IN THE MATTER of a request by Palmerston North City Council for Plan Change E –  
Roxburgh Residential Area

RIGHT OF REPLY TO SUBMITTERS EVIDENCE BY CHRISTOPHER WILLIAM GROOM  
(TRANSPORT)

DATED 15 May 2025

APPENDIX A

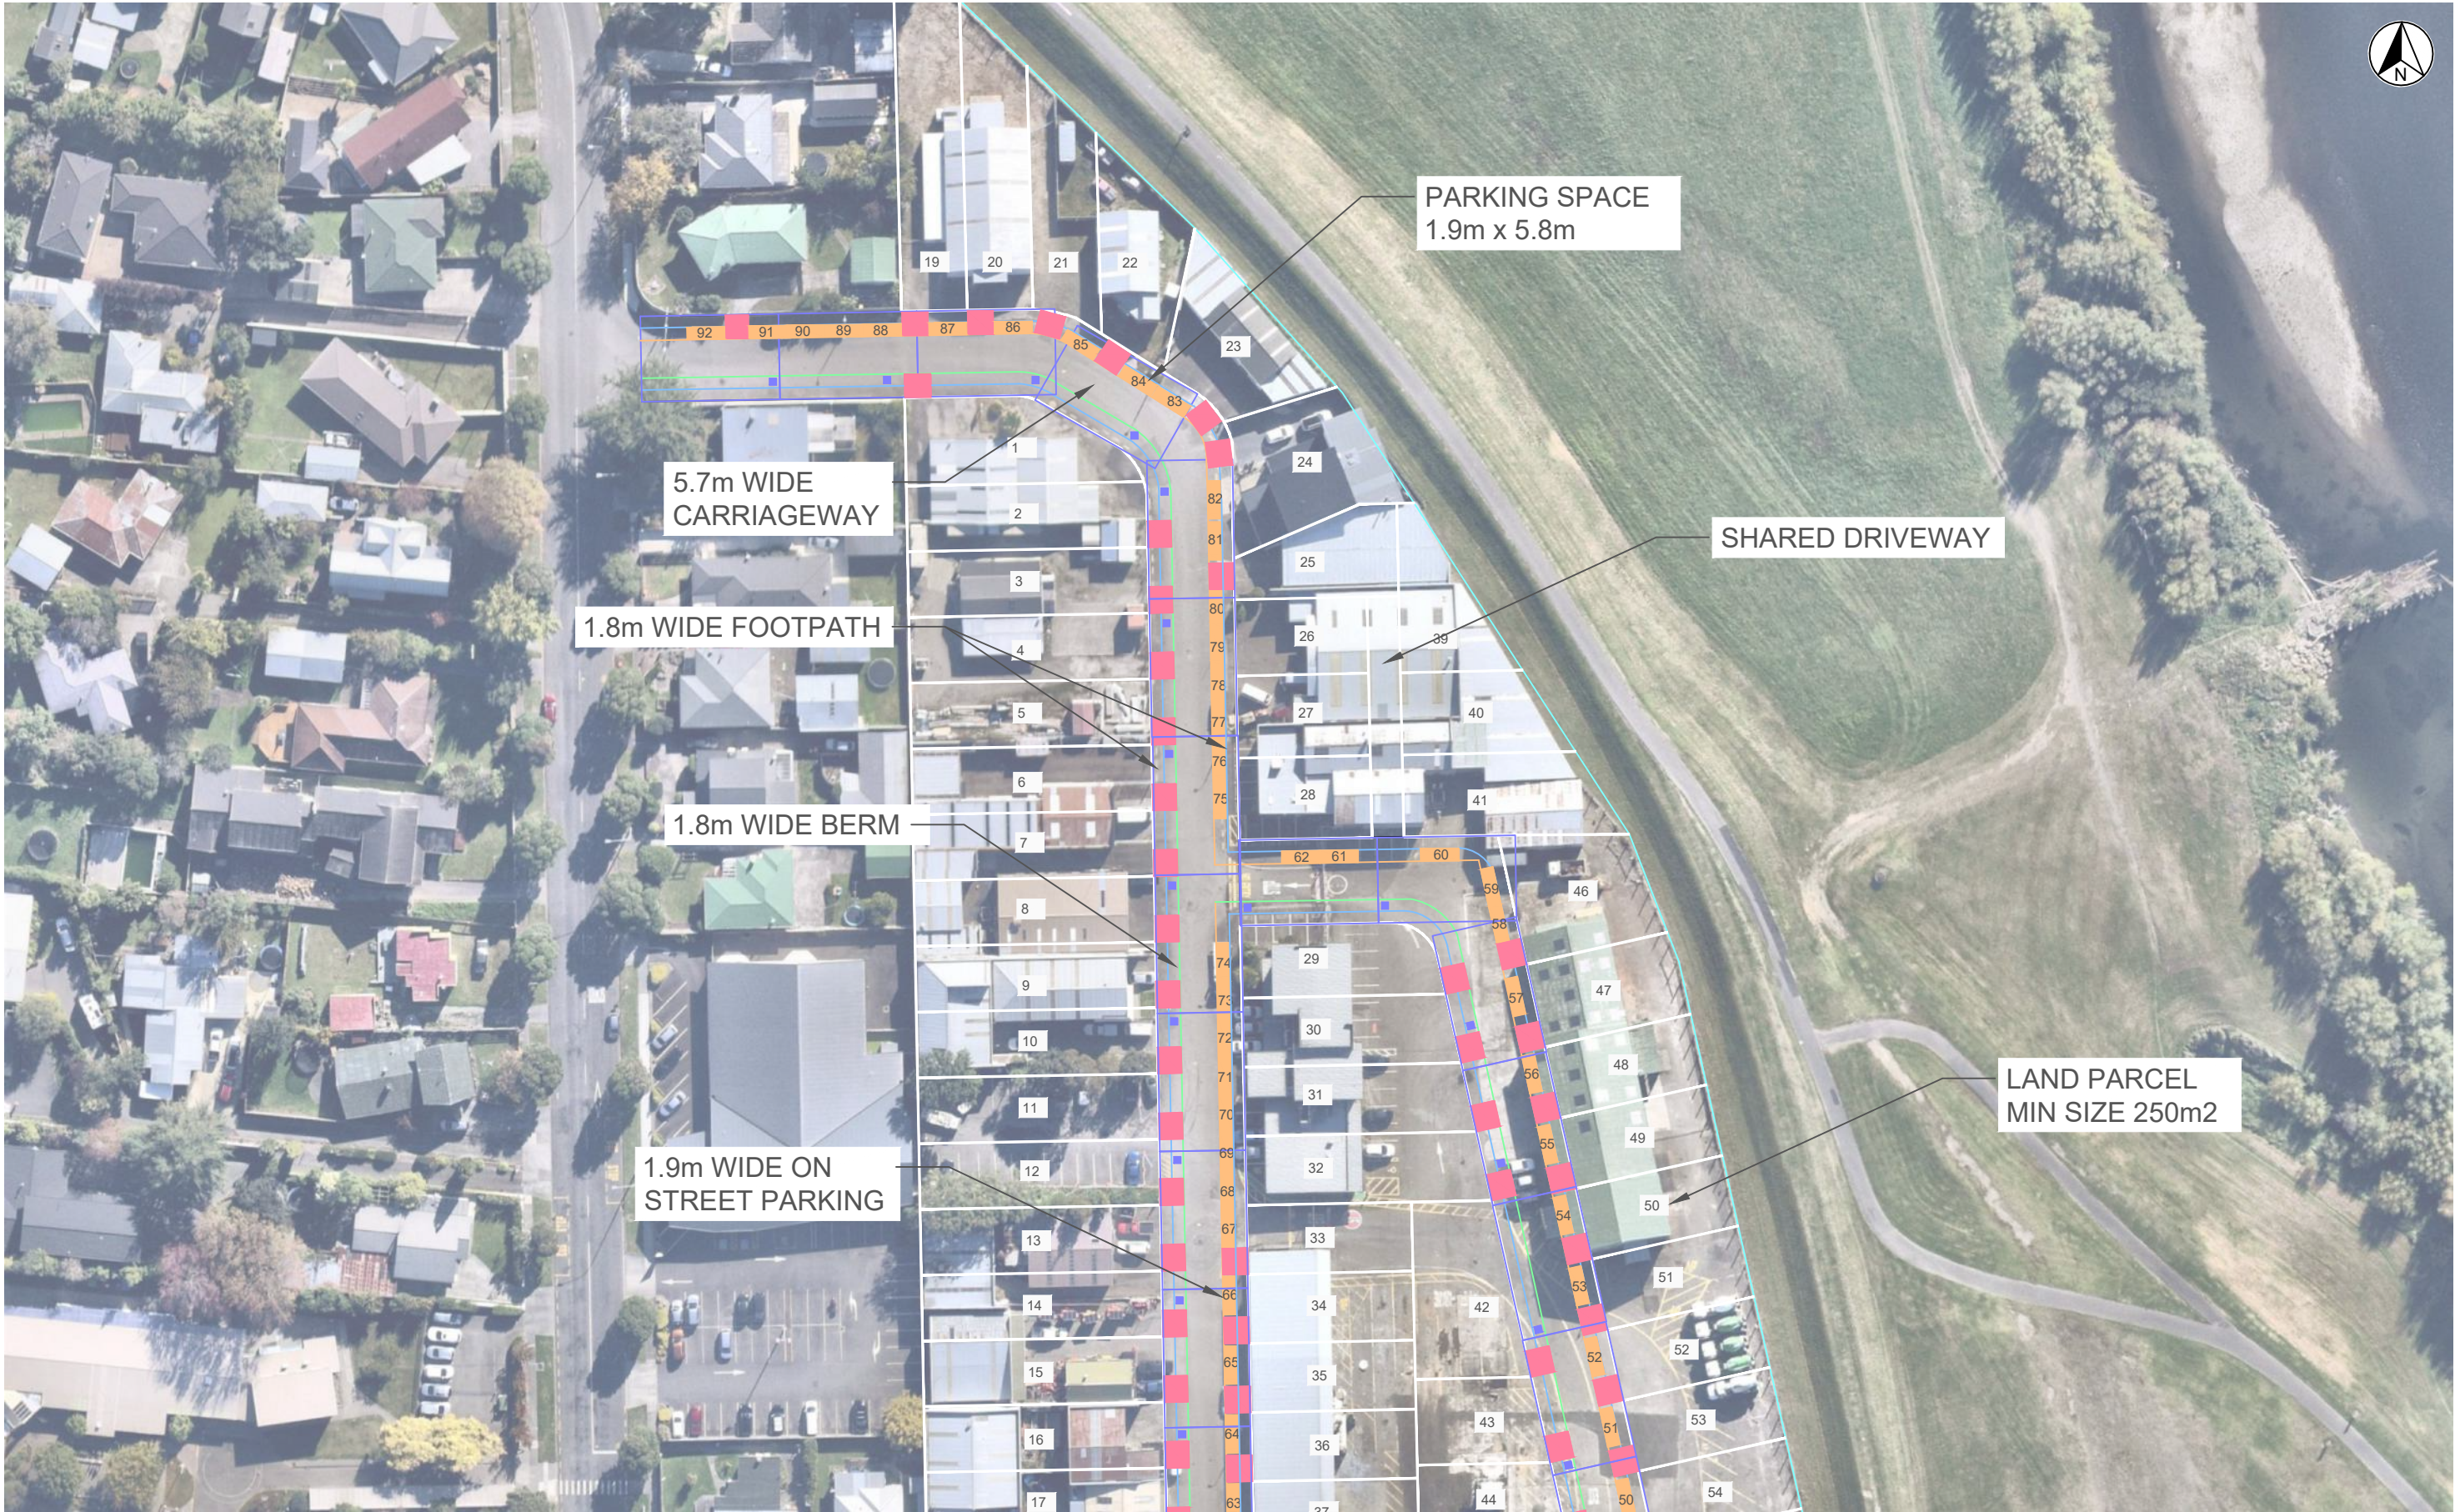
3. The submitter is of the view that insufficient on-street parking would be provided if Roxburgh Crescent is kept at the current width of 13m. The submitter states that parking would be provided on one side of the street and could be one parking space every 15m to 20m when accounting for driveways and biofiltration devices. This implies an on-street parking yield of 18 to 24 parking spaces, with the total length of road within the plan change area being approximately 360m. The submitter has requested that Roxburgh Crescent be widened to 15m to accommodate on-street parking on both sides of the road.

4. I prepared an indicative subdivision following the proposed structure plan (refer to Appendix A) has found that 92 on-street parking spaces could be provided, excluding the angled parking provided for visitors to the Manawatū River corridor. The indicative subdivision plan places the biofiltration devices in the berm rather than on the side of the street with parking, which is a small change from what is shown in the indicative cross-section in the structure plan. This would equate to 0.77 on-street parking spaces per property, assuming 119 residential properties as per the indicative subdivision plan. In my opinion, this would be more than sufficient to accommodate visitor parking demand as not all properties would have visitors at the same time.

5. I do not support the proposal to amend the structure plan to widen street cross sections A and B to 15m on the grounds that additional on-street parking is required. It should be noted that the structure plan does not prevent the developer from providing a wider street should they choose to do so, but the cost of providing the wider street would be borne by the developer and not the council.
